NEBRASKA ARMY NATIONAL GUARD SIDNEY RC INTERIOR SUSTAINMENT

Sidney Readiness Center
2225 Legion Park Road
Sidney, NE 69162

PROJECT NO. 31030399

A D D E N D U M N O . 2

K1 GENERATOR PAD PLAN
C210 SCALE: 1"=1'-0"

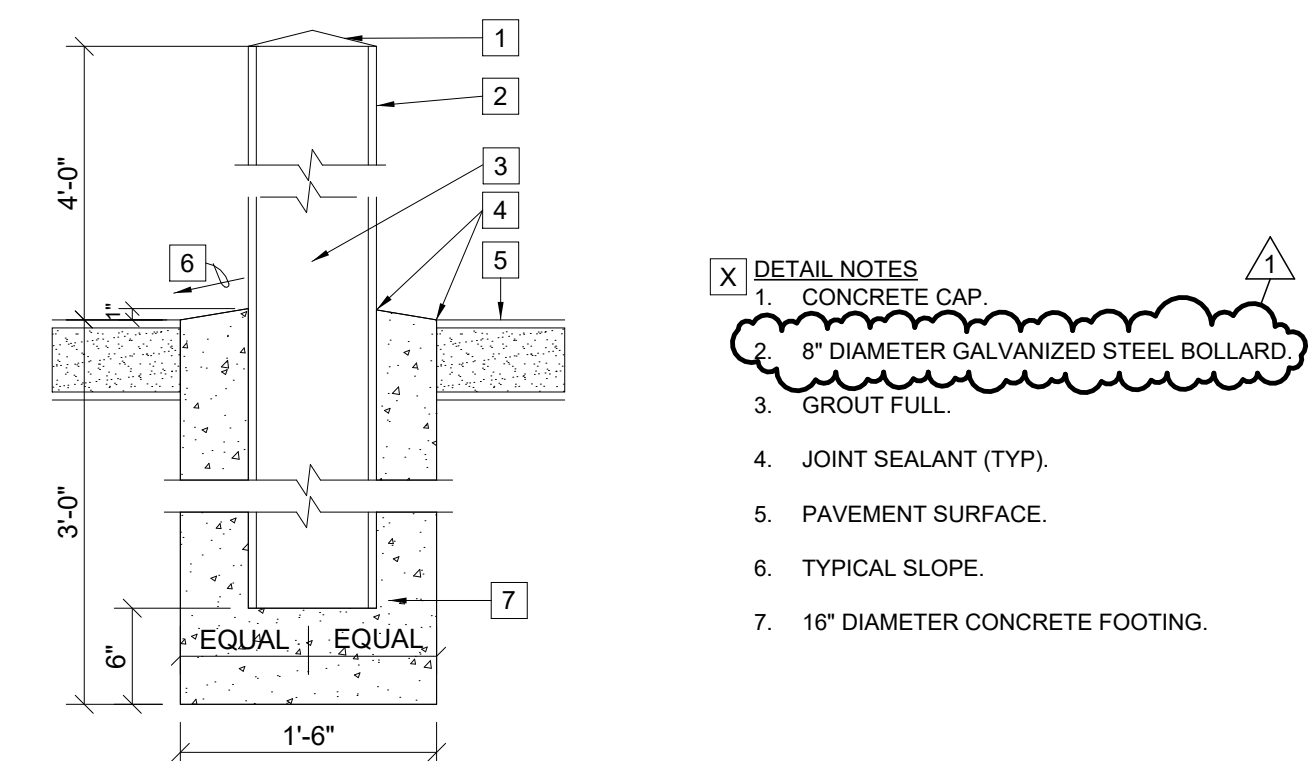
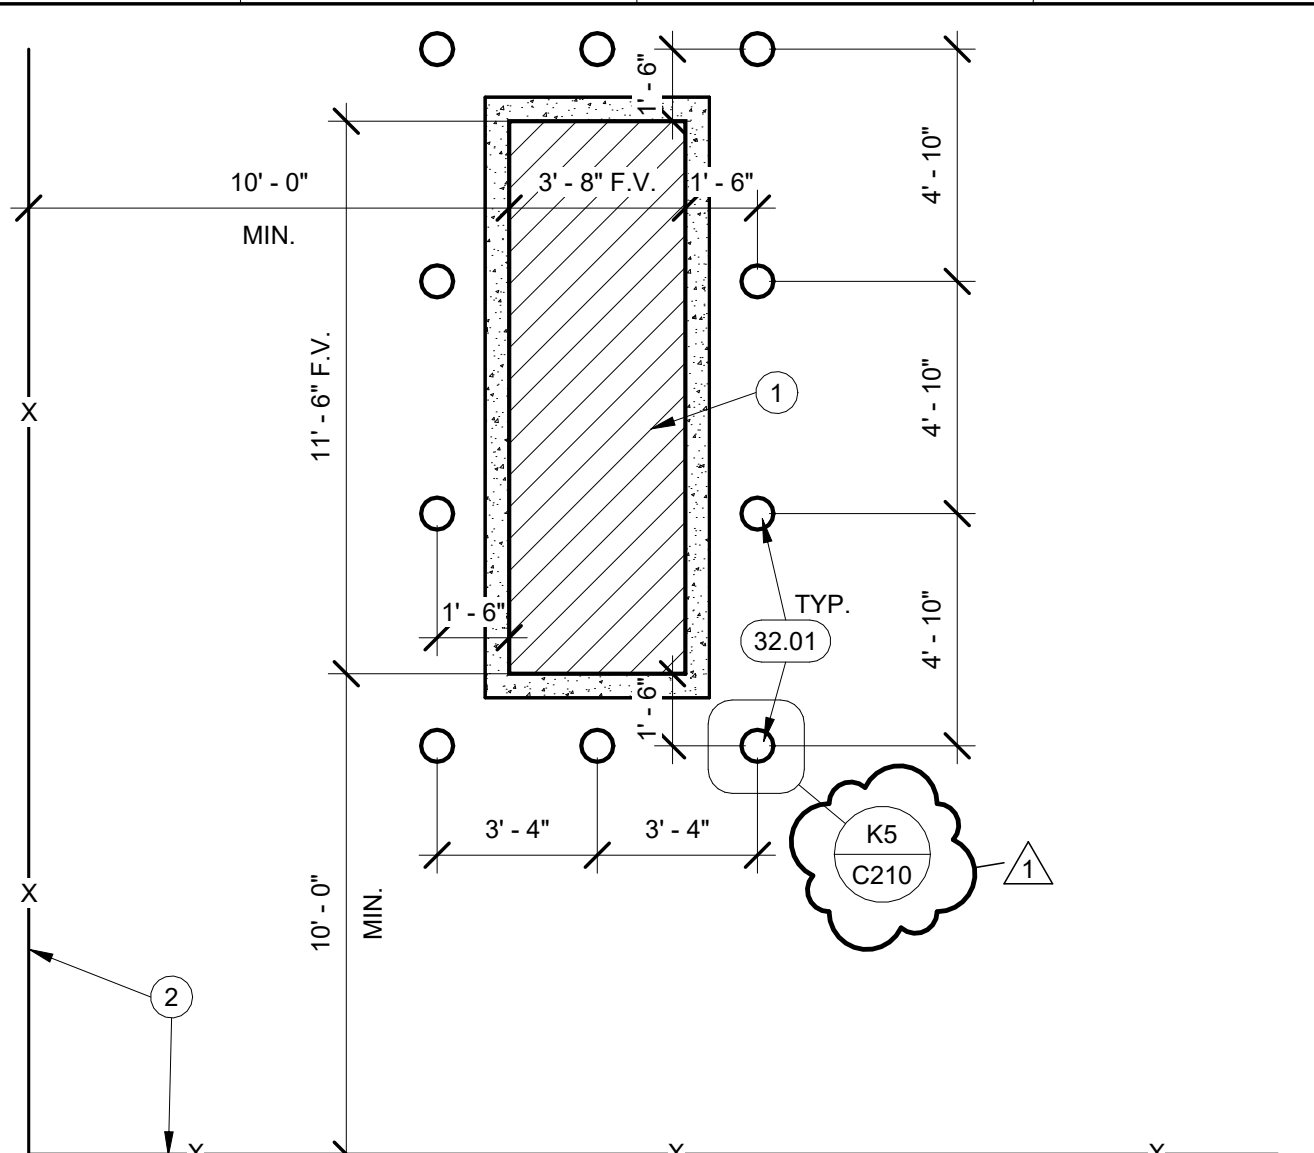
2. Detail K9 Generator Bollard Placement.
 - a. Revise detail callout 2/C210 to be K5/C210.
3. Detail K5 Bollard Detail
 - a. Revise detail note 2 to be, “8” diameter galvanized steel pipe bollard.”

4. Added detail K1 Generator Pad Plan, for generator pad plan and pier footings for clarification.
5. See attachment #2.

A1 SITE PLAN - NEW
C210 SCALE: 1"=1'-0"

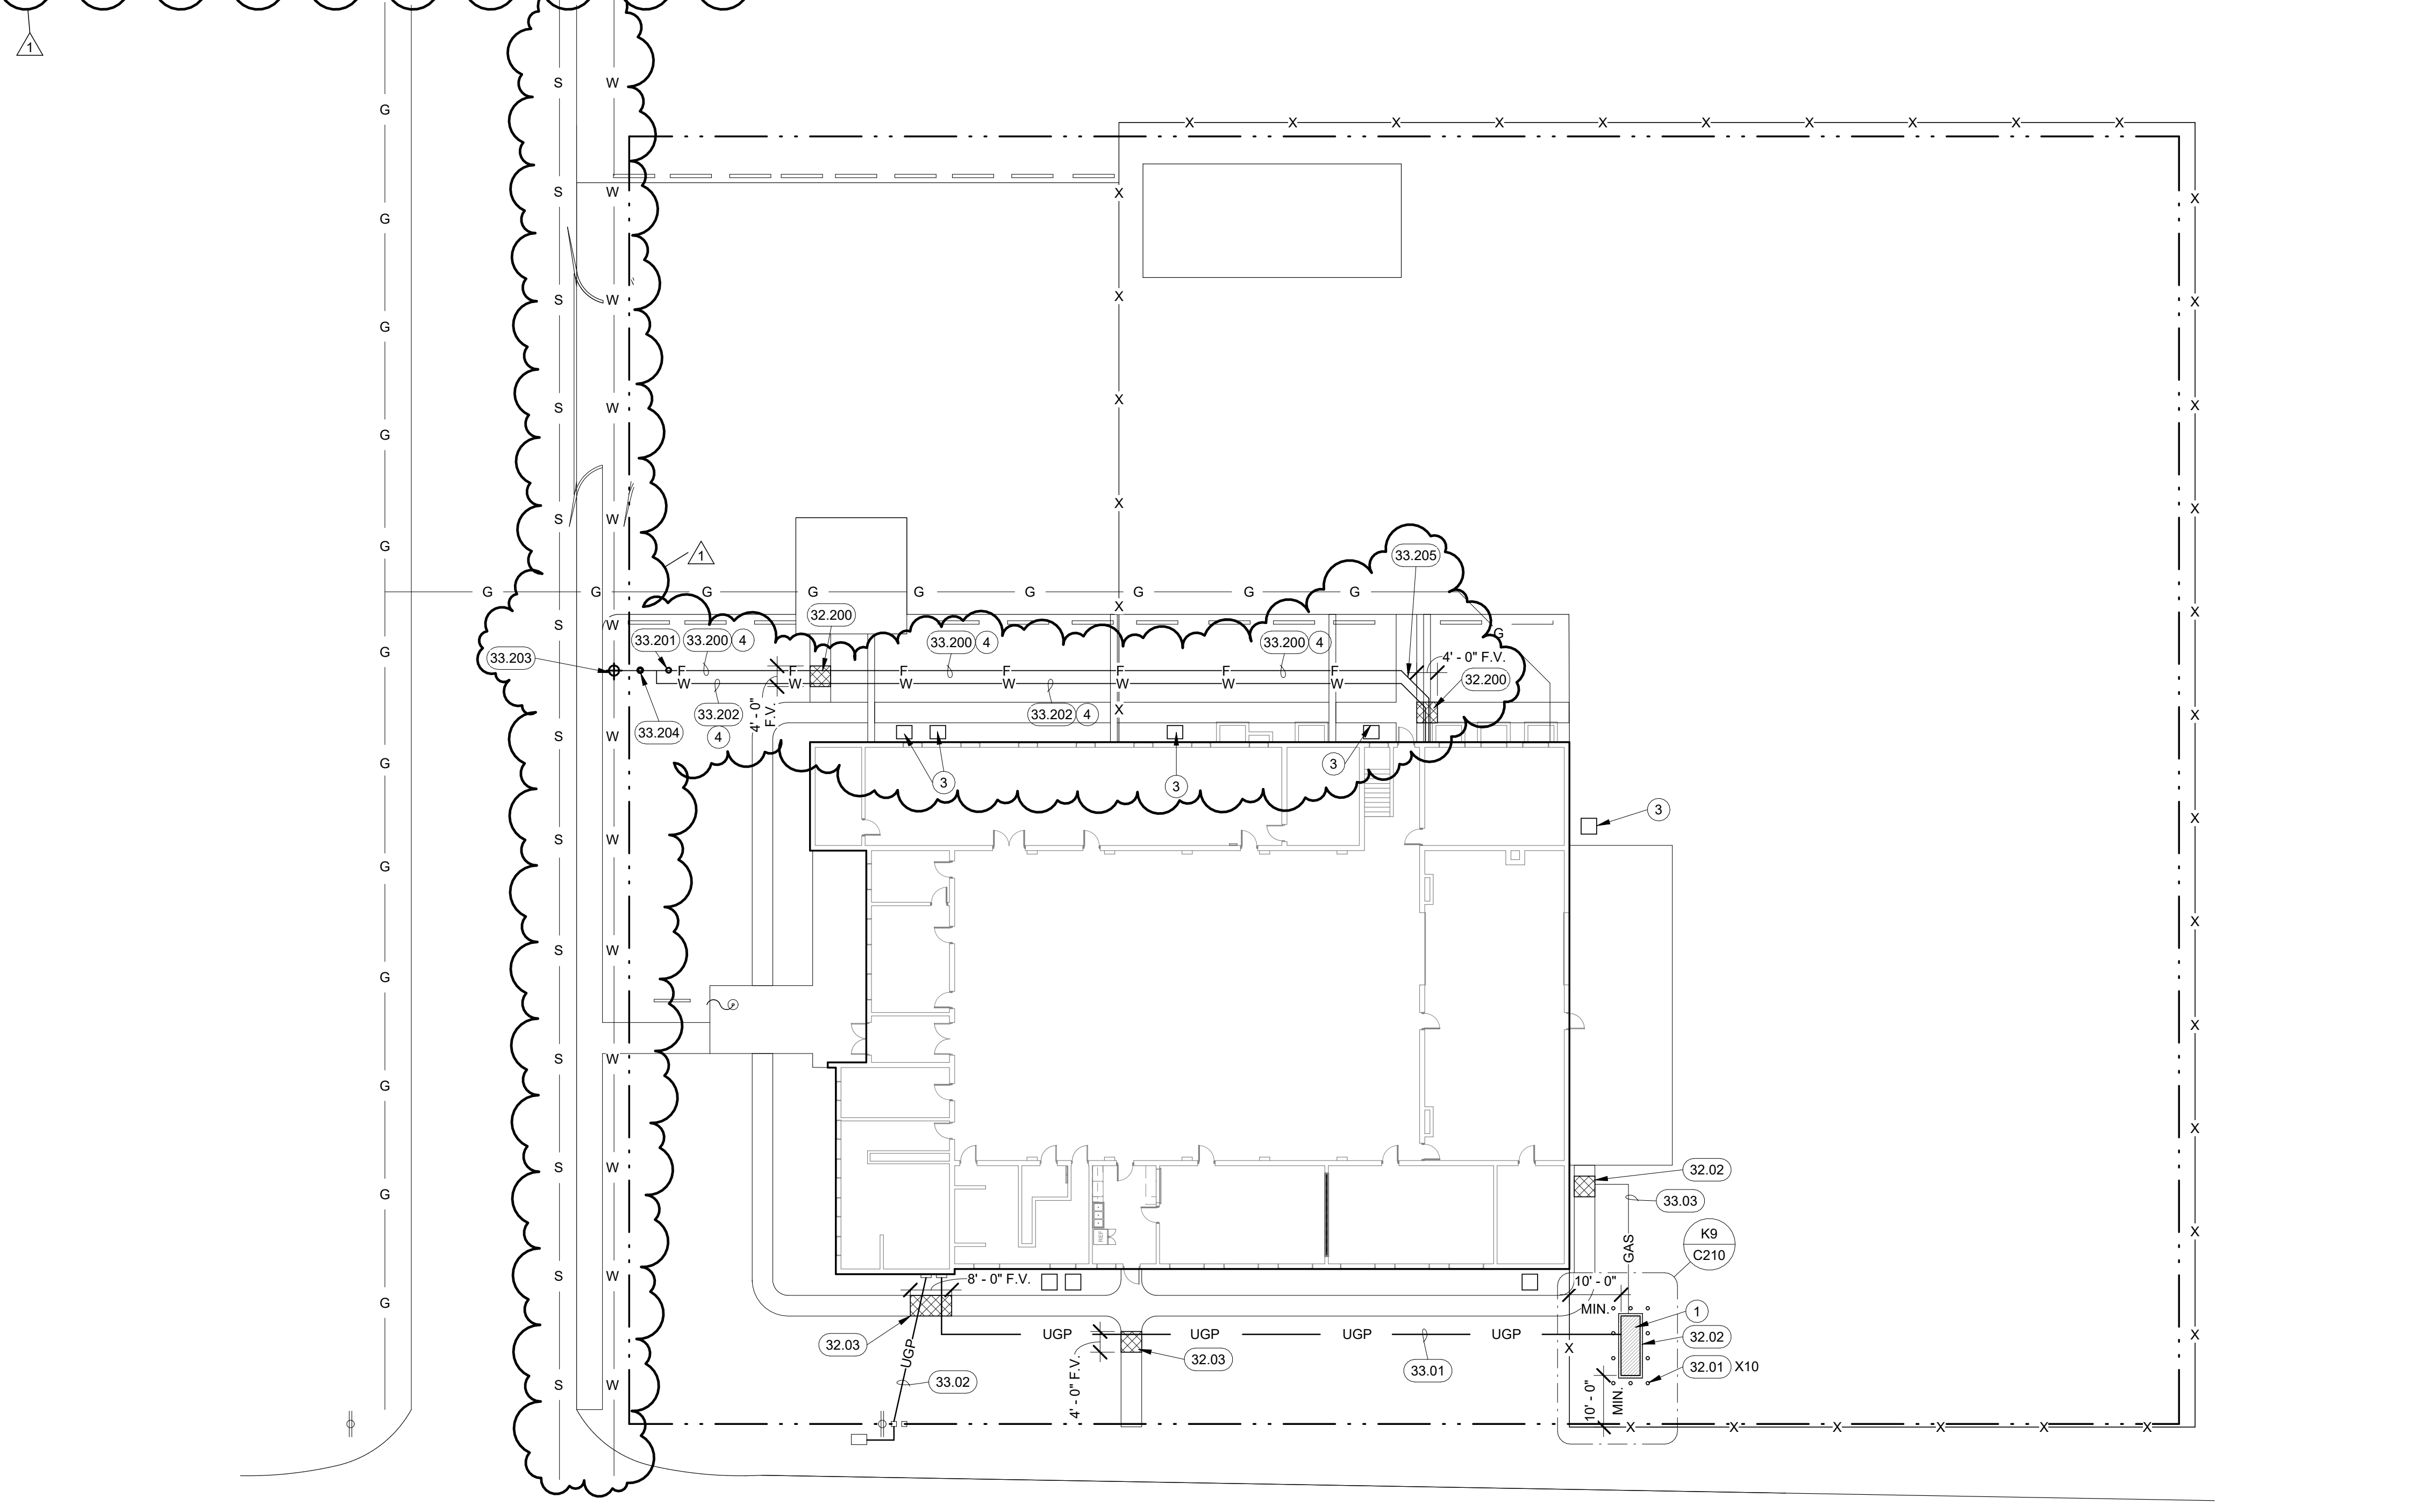
ADD 2-5 Reference Drawings C210 Site Plan – New:

1. Detail A1, Site Plan New
 - a. Existing water main and existing sewer main route clarified in drawings.
 - b. Add post indicator valve.
 - c. Add new 2” water service line to building, tee off before new post indicator valve.

- d. Add keynote 33.201, “Provide and install post indicator valve.”
 - e. Add keynote 33.202, “Tee off 2” water service to building prior to post indicator valve.”

- f. Add keynote 33.203, “Tap new 6” water service line into existing main. Provide wet tapping sleeve.”
 - g. Add keynote 33.204, “Curb stop isolation valve.”

- h. Add keynote 33.205, “Provide and install thrust block at change in direction.”
 - i. Add sheet note 4, “Pipe to be AWWA DR18 C900 PVC pipe, verify with local municipality.”

A1 MAIN LEVEL FLOOR PLAN - NEW

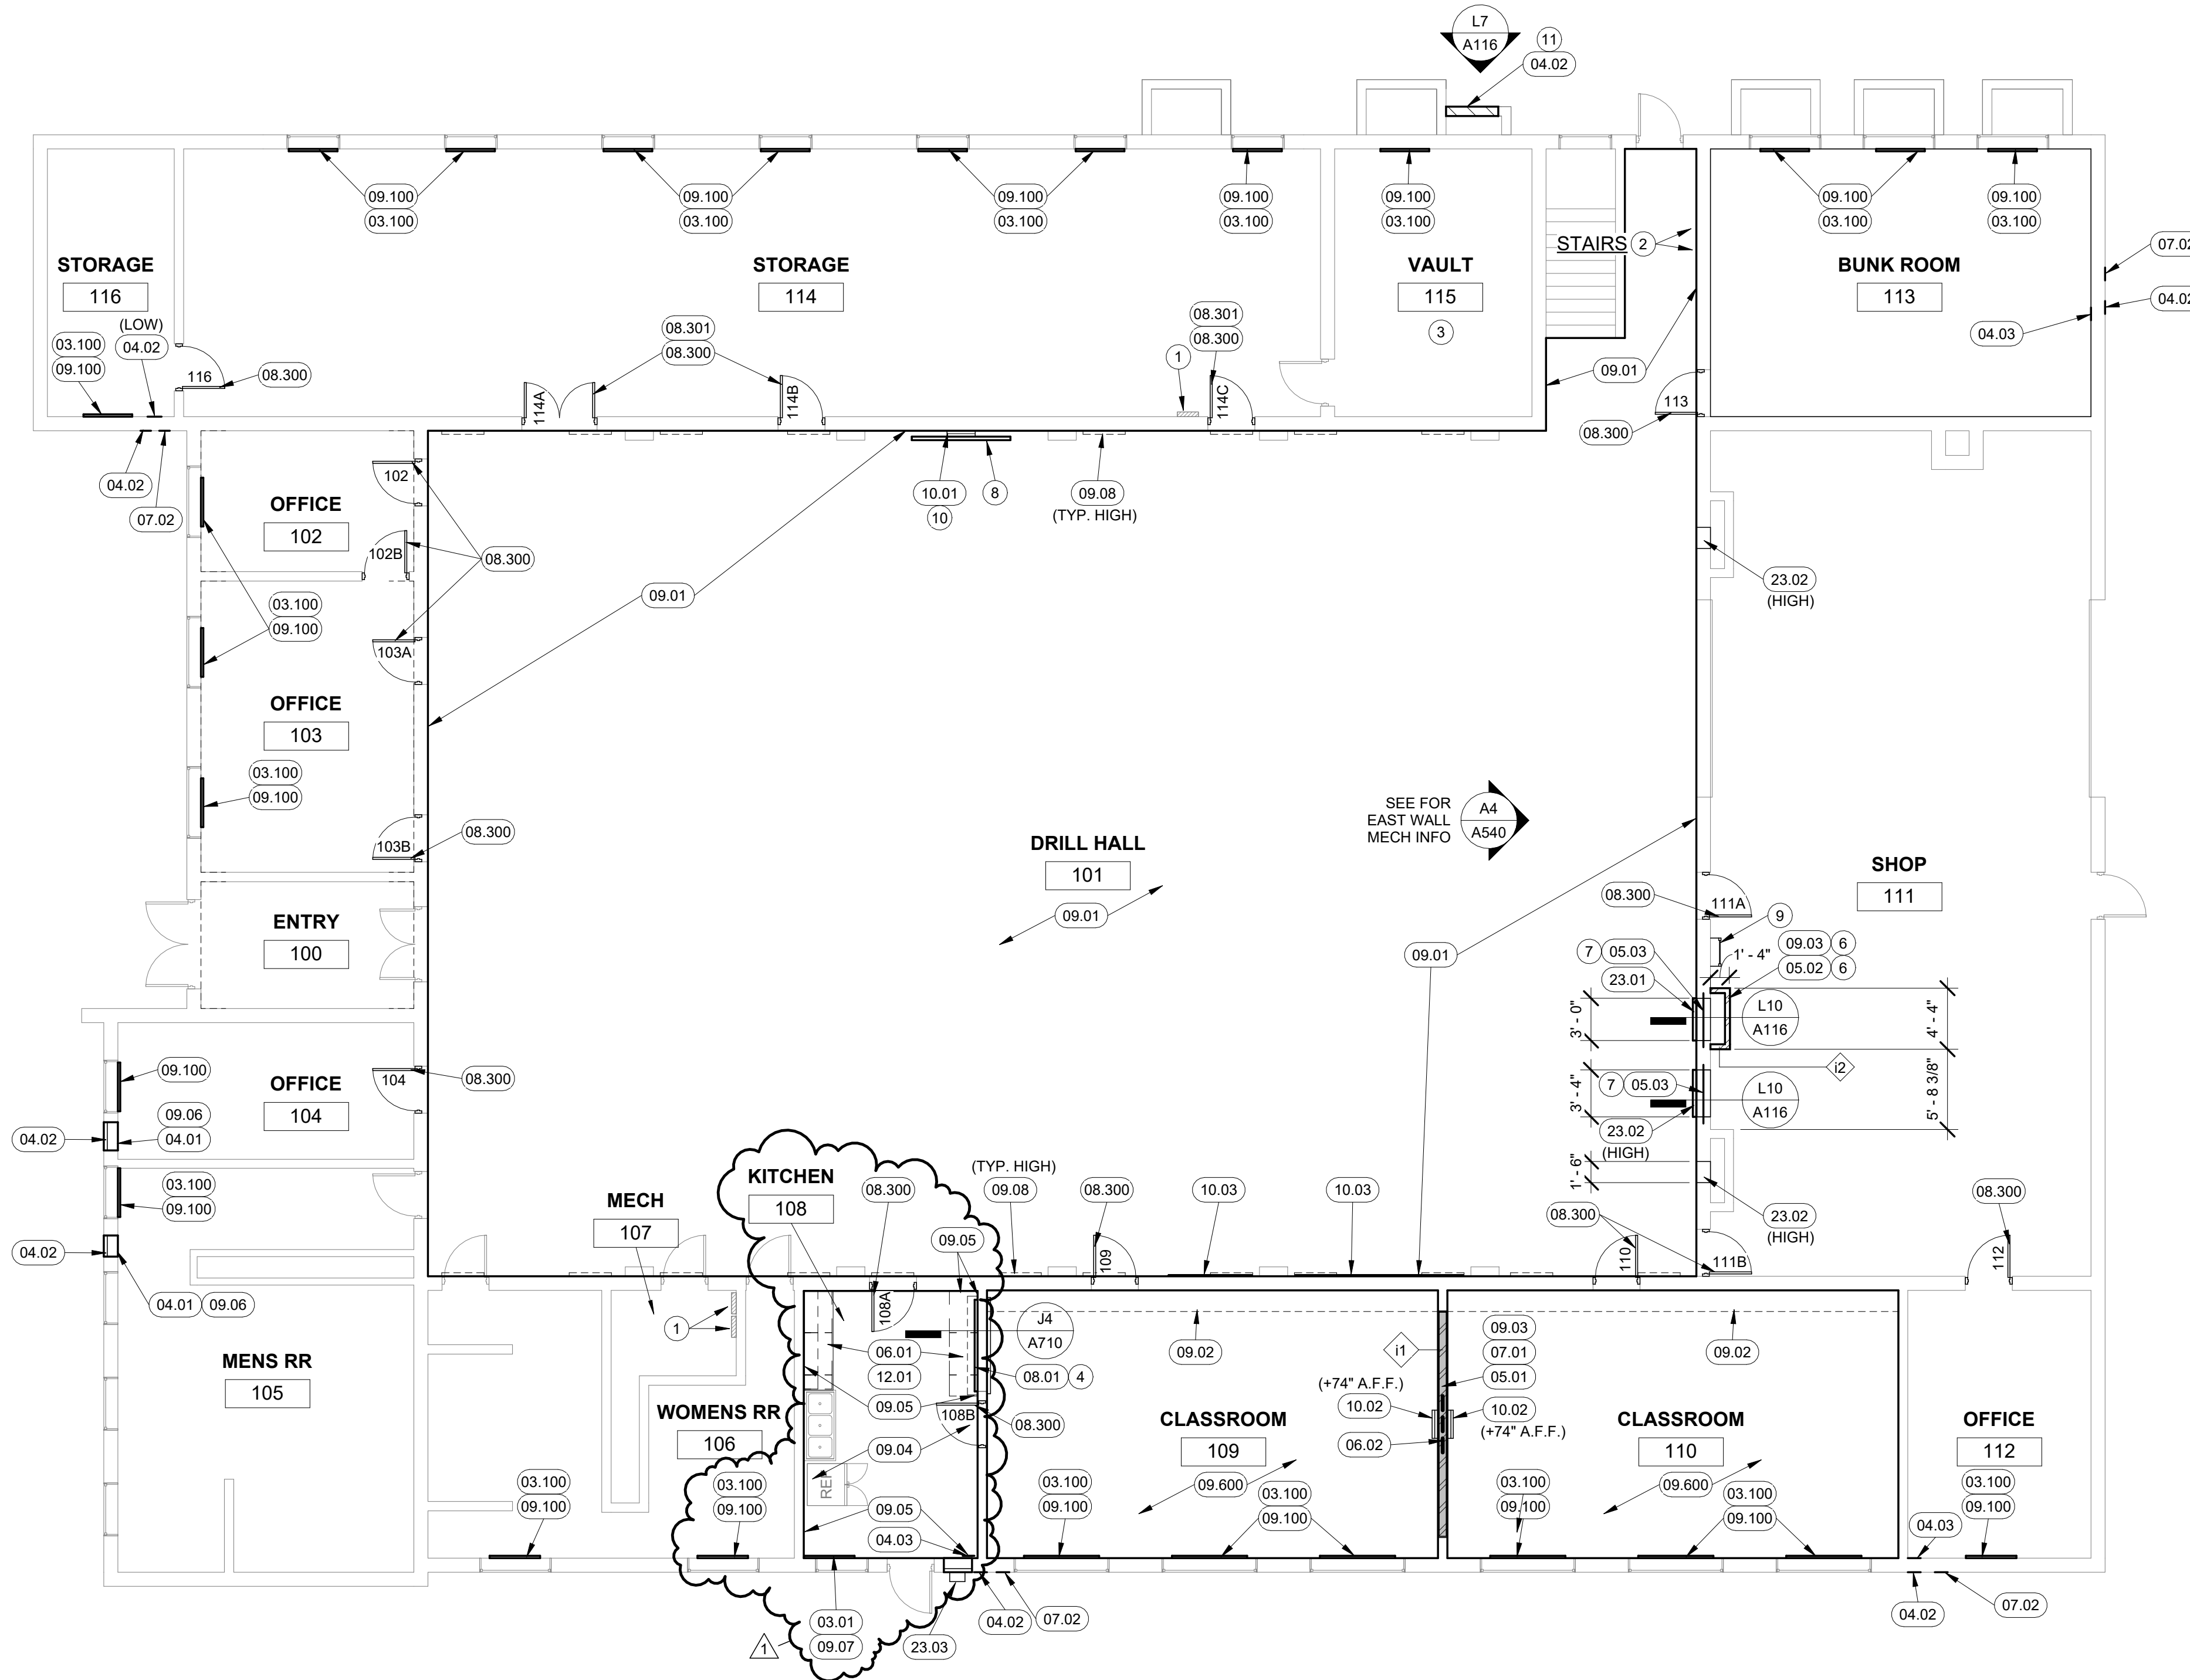
ADD 2-6 Reference Drawing A116 Main Level Floor Plan – New, Detail A1, Main Level Floor Plan – New:

1. Clarification, unit heater removal and patch at Kitchen 108 to be part of base bid.
 - a. Revise keynotes as shown in the attachment.
2. Add keynote 09.05 to areas of backsplash removal at Kitchen 108 as shown in the attachment.
3. See attachment #3.

L4 CEILING TRANSITION DETAIL
A216 SCALE: 1"=1'-0"

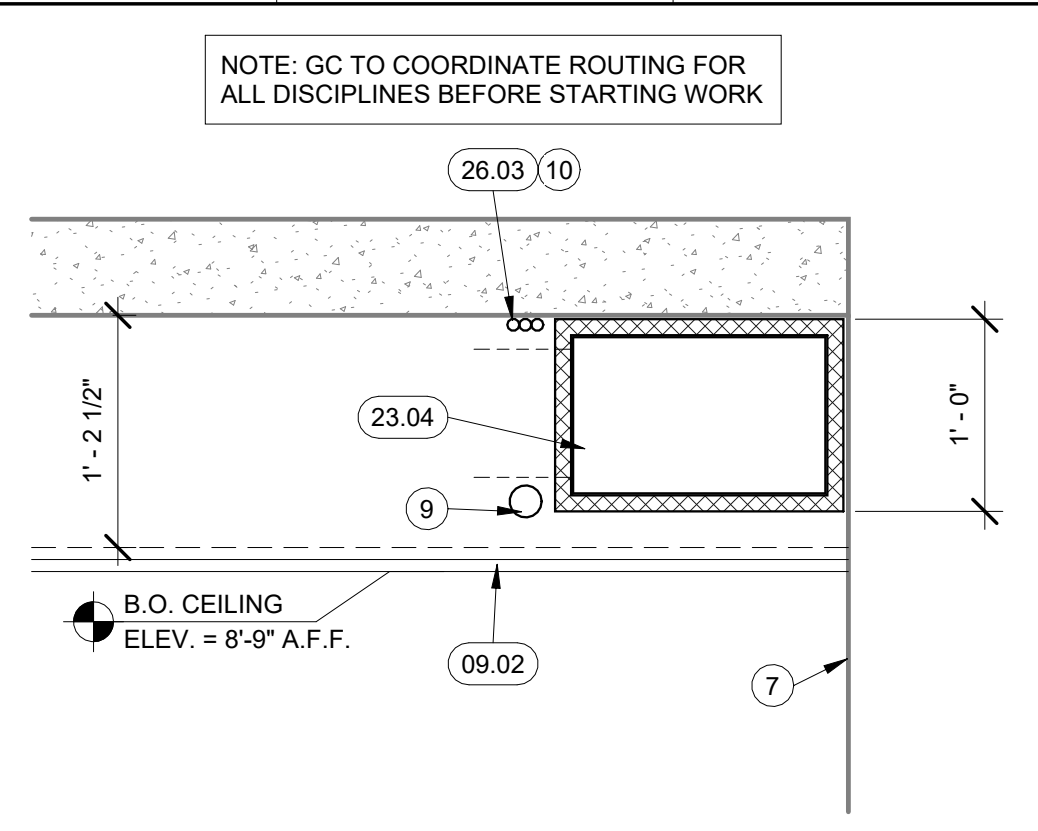
1. Detail A1, Main Level Reflected Ceiling Plan – New
 - a. Add ceiling transition detail at Office 102.
 - b. Add section callout L4/A216 for ceiling transition trim detail.
 - c. Add keynote 02.01, “Cut existing storage caging for new duct work.” at new duct in Storage 114.
2. Add detail L4 Ceiling Transition Detail for ceiling transition detail.

3. Add keynote 09.07, "Axiom ceiling transition trim."
4. Add sheet note 12, "Existing window opening."
5. See attachment #4.
